In the Drawings:

In compliance with the Examiner's requirements, Applicant submits a set of marked-up informal drawings with proposed added legends for various boxes in each drawing. This set of drawings is informal and the added legends should be helpful to the examination of the application by showing the actual device name of each box.

Fig.5

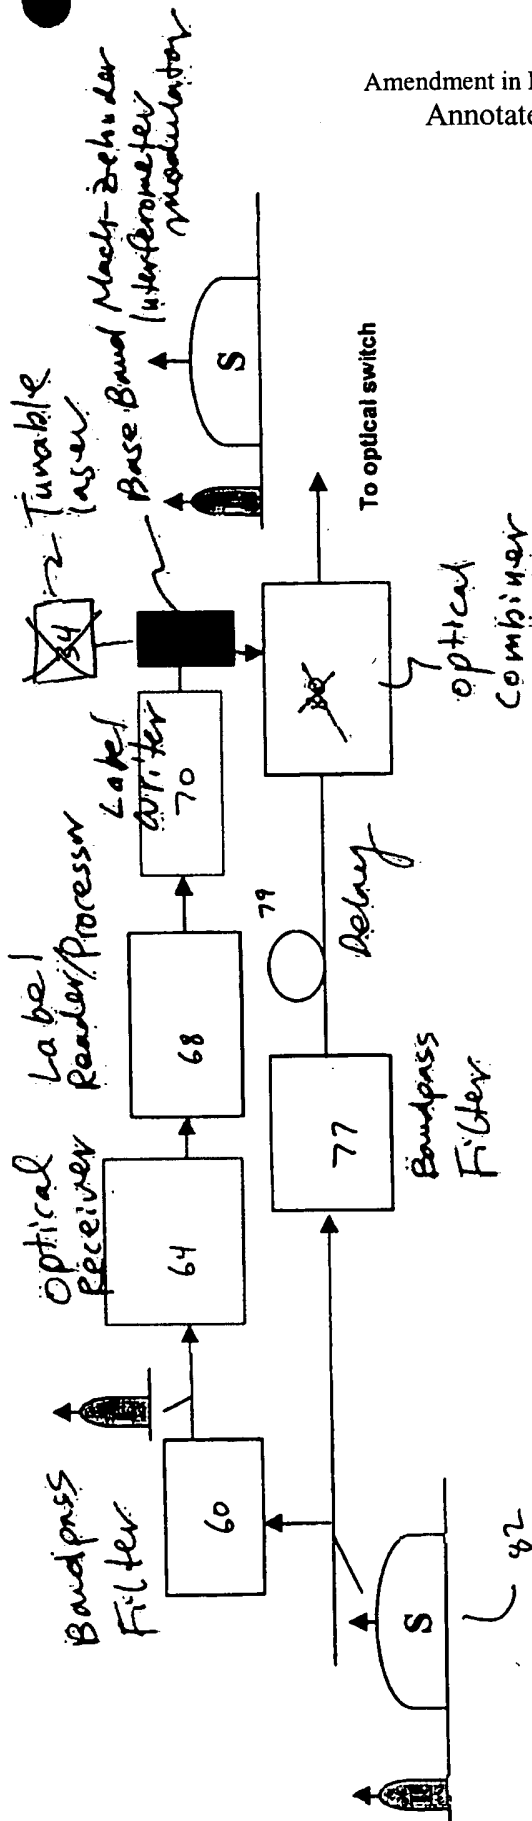
FIG. 5 as originally filed appears to have incorrect numerals and have been corrected in the proposed drawings. Specific details for corrections in FIG. 5 are as follows.

The box "34" should be labeled with a different numeral number because this box is described as a tunable laser on page 13, lines 10-11 of the original specification. Hence, Applicant proposes to remove the numeral "34" and label it as "tunable laser" as marked in red.

The box underneath the box originally labeled as "34" should be a base band Mach-Zehnder interferometer modulator according to the textual description on page 13, lines 10-11 of the original specification. Accordingly, this box is proposed to be labeled as "base band Mach-Zehnder interferometer modulator."

It appears that the box "77" is not explicitly described in text in the original specification. However, based on the description for FIGS. 5 and 6 on page 13 and the description on other implementations in the original specification, it can be readily inferred that the box "77" represents a bandpass filter that rejects a channel "L" having the label information and passes the signal channel "S" having data. Accordingly, the box "77" has been labeled as such and additional text has been proposed to add in the paragraph beginning on page 13, line 4 to reflect this.

Finally, the box originally labeled as "80" should be an optical combiner to combine the signal optical wave without the original label signal and the optical signal with the new label information produced by the base band Mach-Zehnder interferometer modulator. This can be readily inferred from the original specification. Since the numeral "80" is already designated as an optical modulator in FIG. 3(a), it is proposed that the numeral "80" be removed and replaced with a text label of "Optical Combiner" as marked in red in the amended FIG. 5.
